400 Chestnut Street Tower II

October 2, 1979

Enclosed are responses to Reactor Systems Branch questions (items 212.104 through 212.114) on Loss of Coolant Accidents (LOCA) transmitted by your letter to H. G. Parris dated August 21, 1979. These responses will be incorporated into the Sequoyah Nuclear Plant Final Safety Analysis Report by Amendment 62.

RESPONSES TO REACTOR SYSTEMS BRANCH QUESTIONS

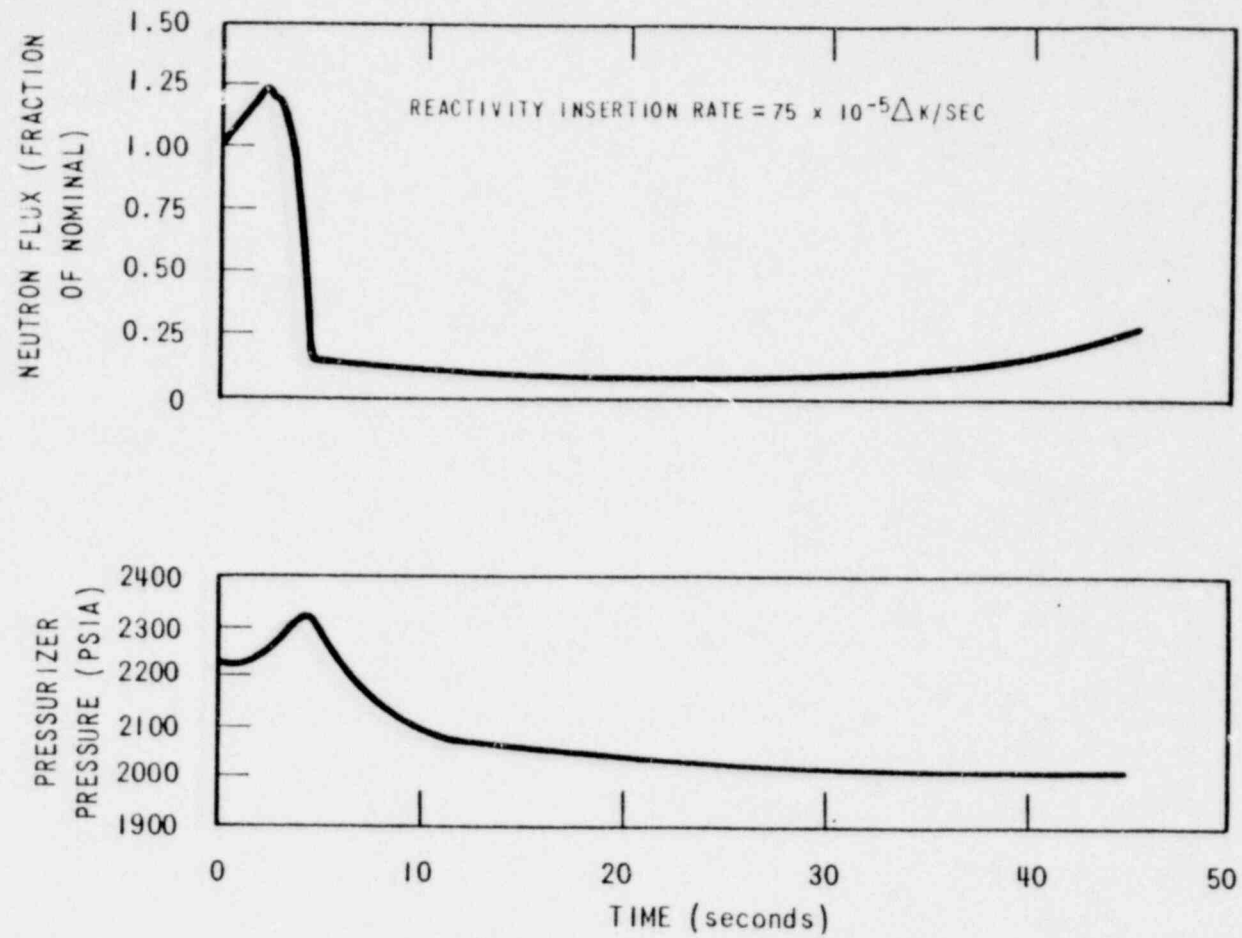
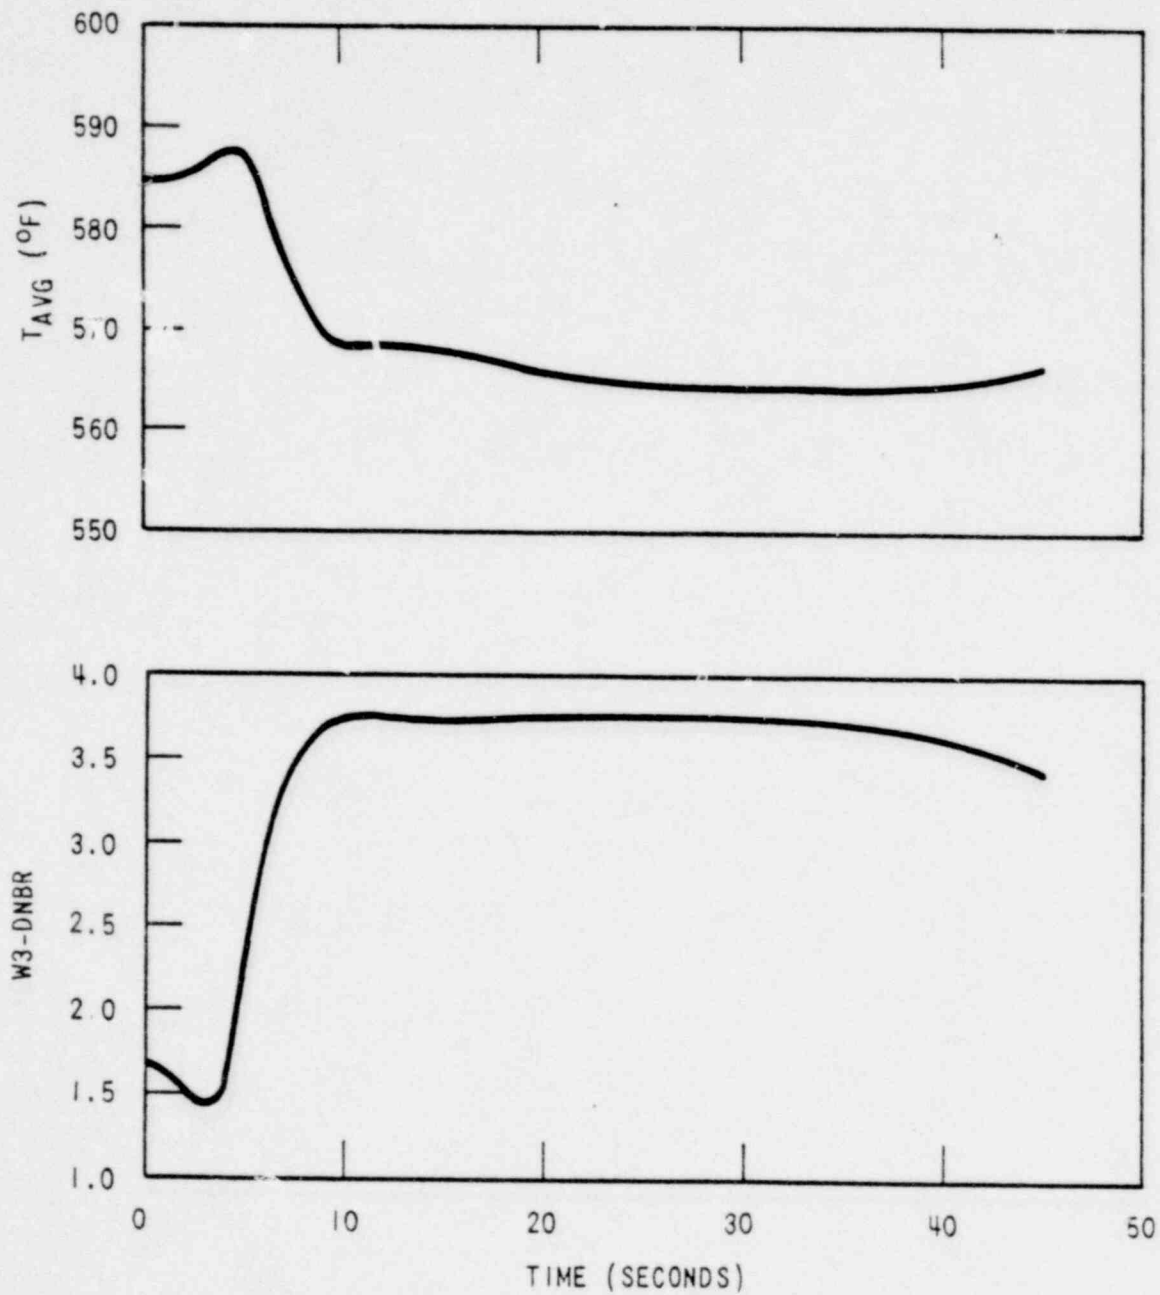
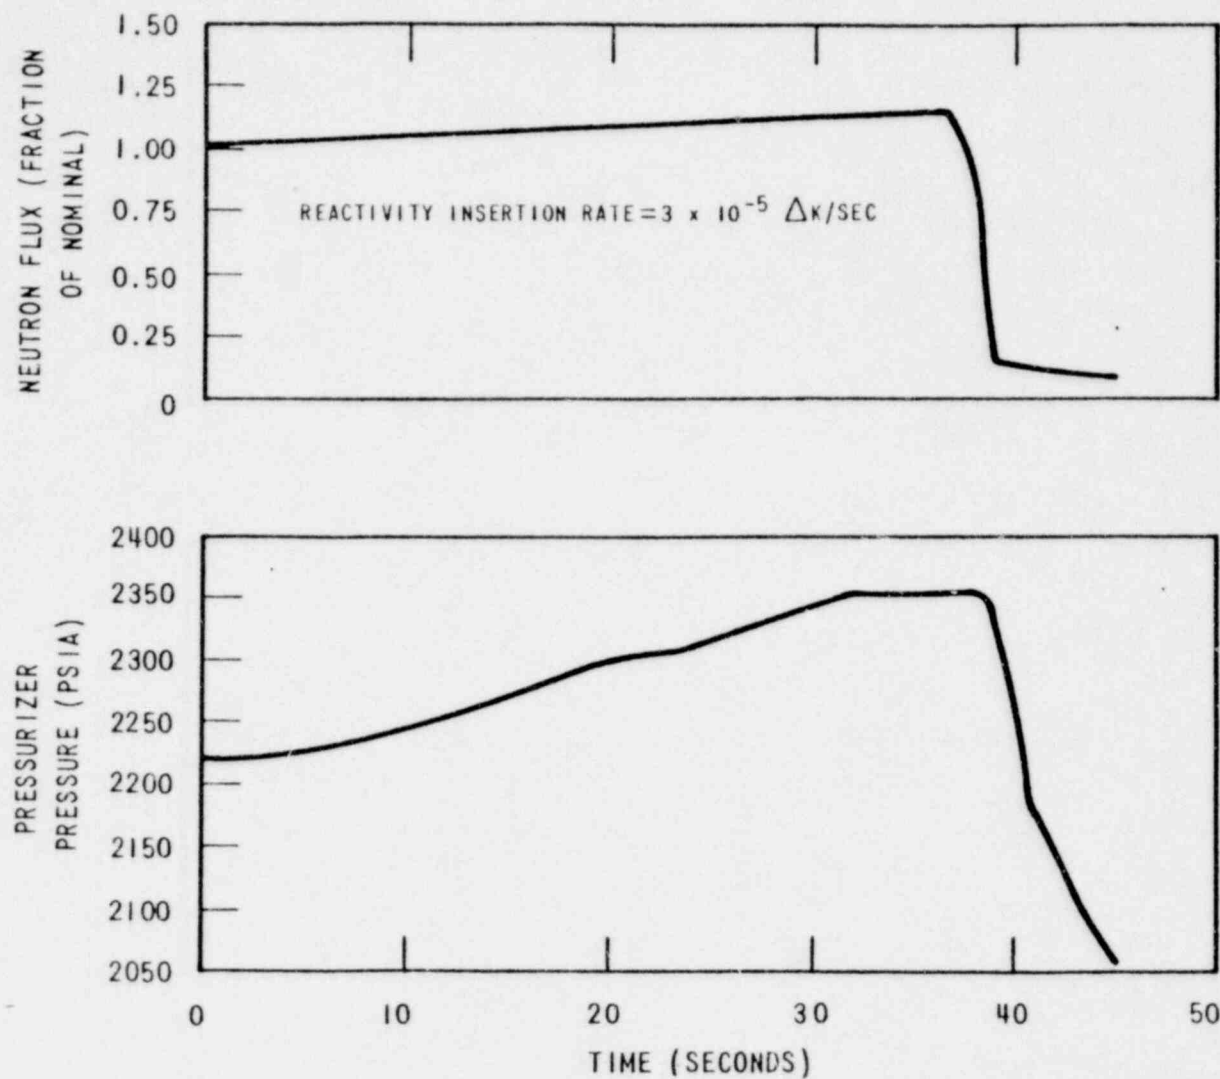
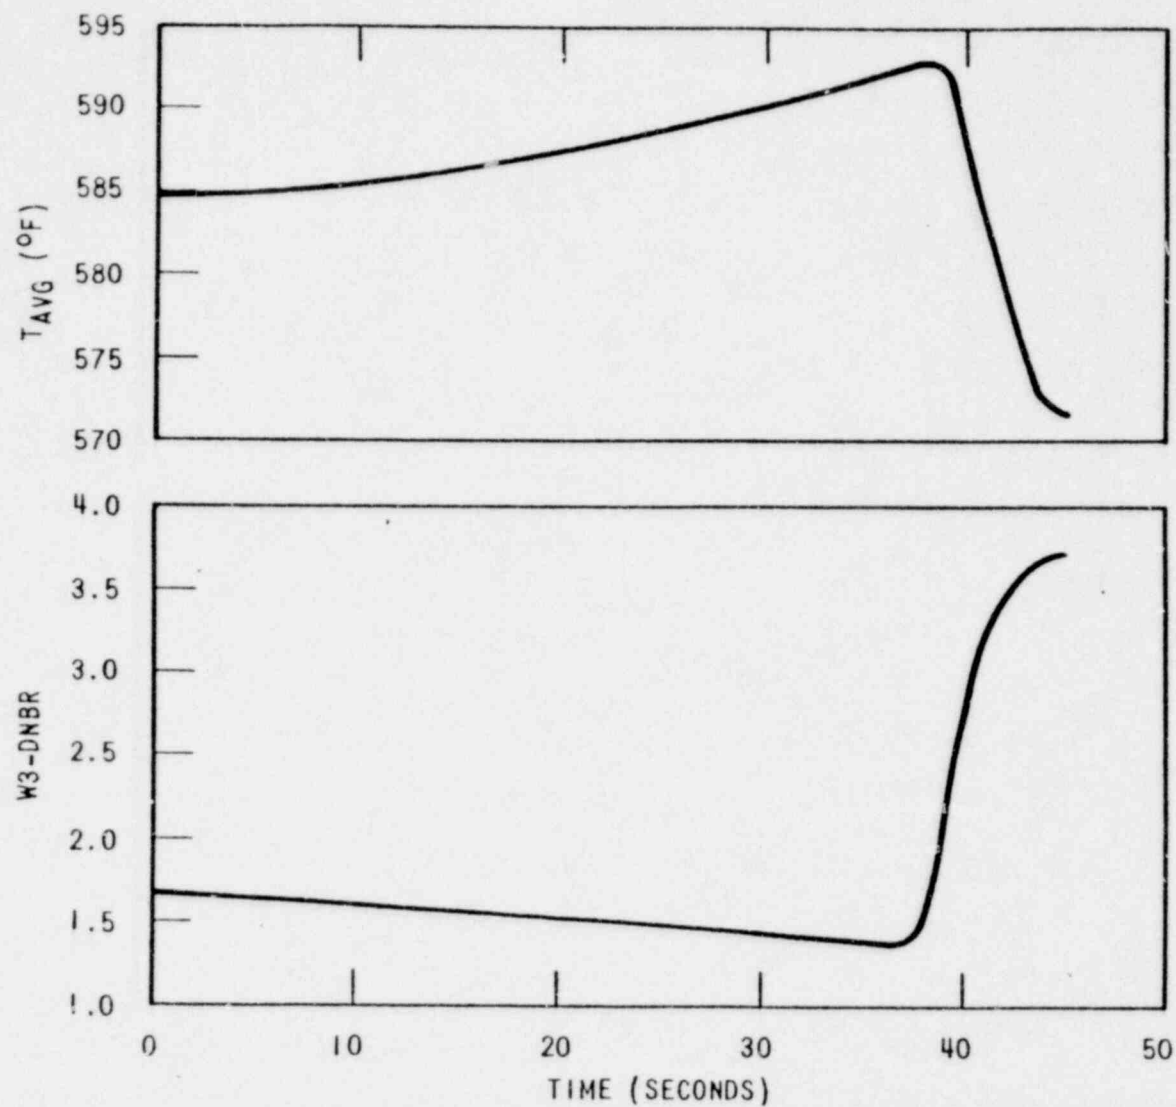
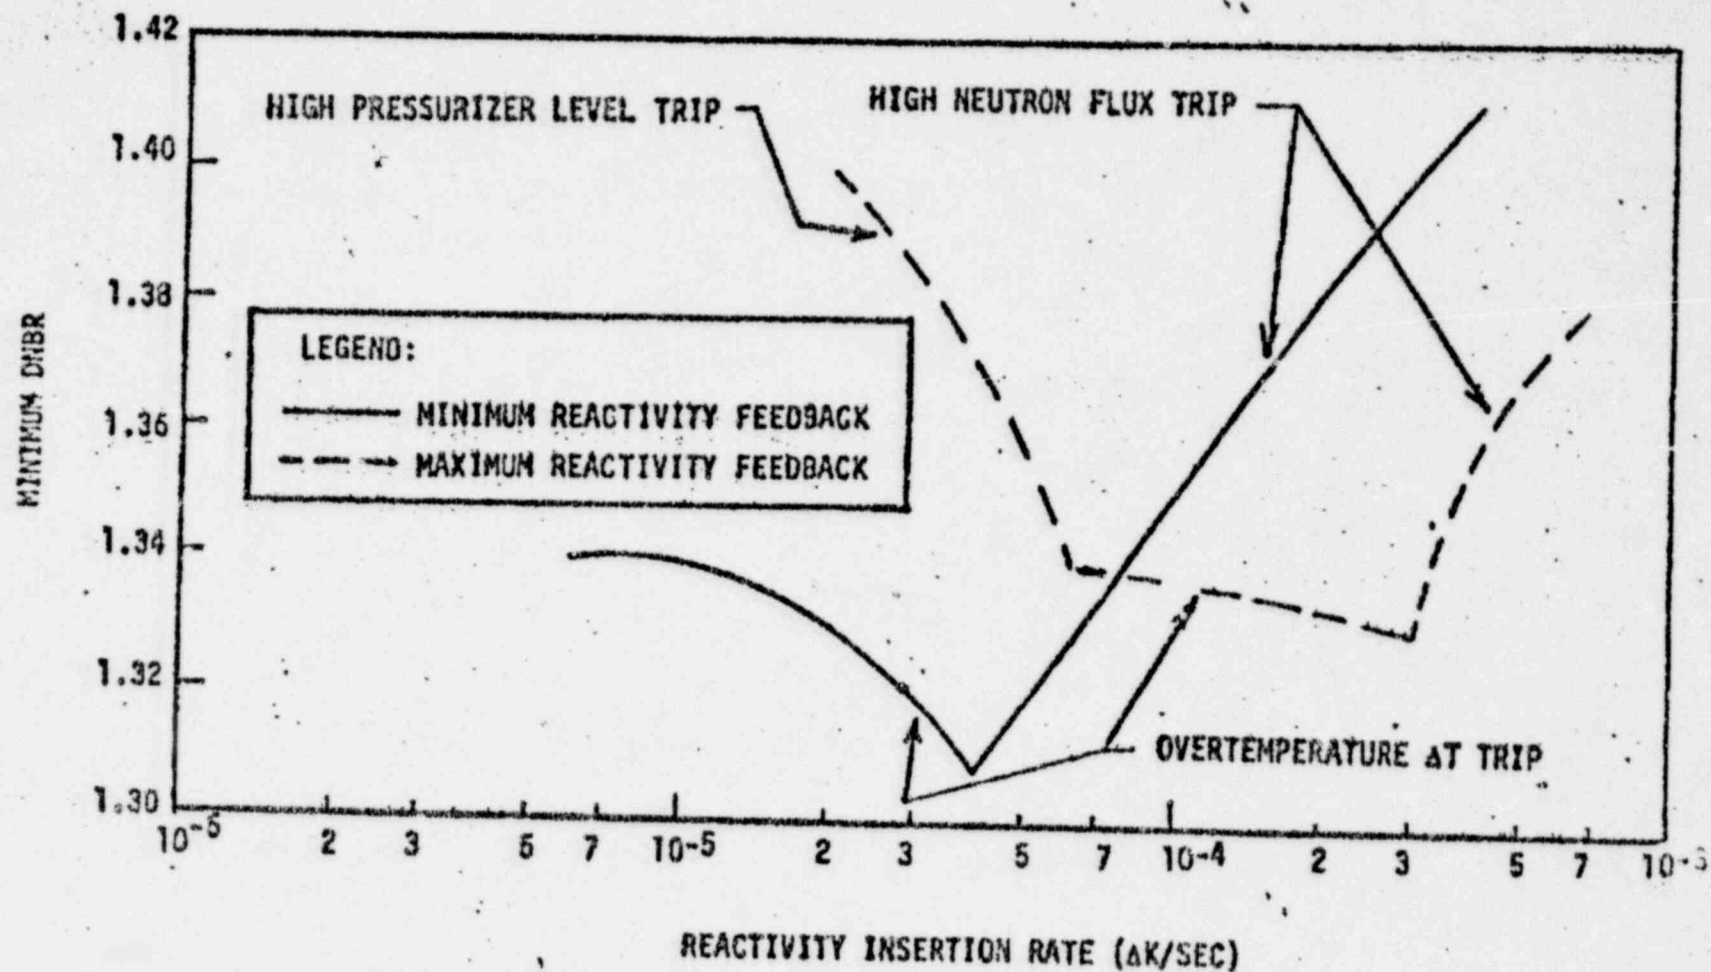
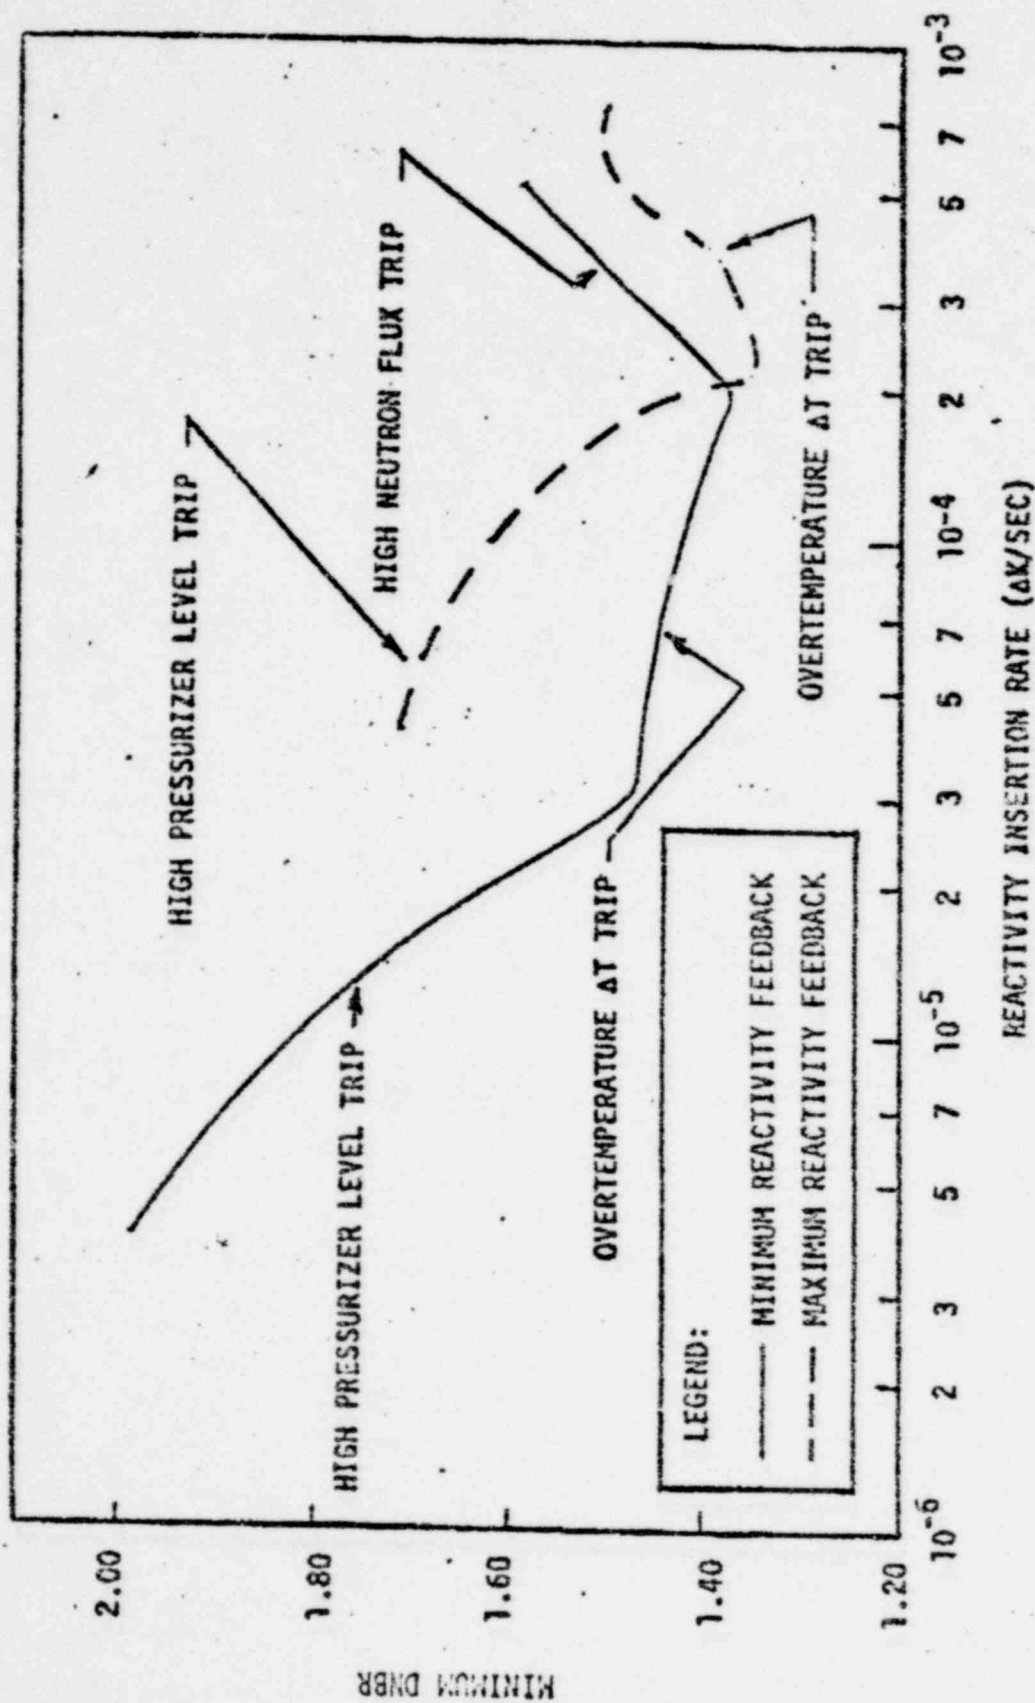
- (212.106) The response to Q15.26 has discussed temperature measurement and modifications to Sequoyah reactor internals that would increase bypass flow to assure that 4 percent of the total cold leg flow would enter the upperhead region to maintain the upperhead region temperature at the cold leg value. The response has not addressed concerns about the impact of this increased bypass flow on Chapter 15 analyses. Please address this concern.

An increase in core bypass flow affects the overtemperature  $\Delta T$  protection setpoint calculation. The appropriate setpoint and Tech Spec revisions have been made. The overtemperature  $\Delta T$  trip is required for protection during transients which approach DNB. This trip is most important during the slow rod withdrawal at power event.

The rod withdrawal at power accident has therefore been reanalyzed, using the adjusted overtemperature  $\Delta T$  setpoints. The conclusions drawn in the FSAR are unchanged for this new analysis (i.e. the DNBR does not fall below 1.30). Appropriate revisions have been made to Section 15.2 to reflect this new analysis.
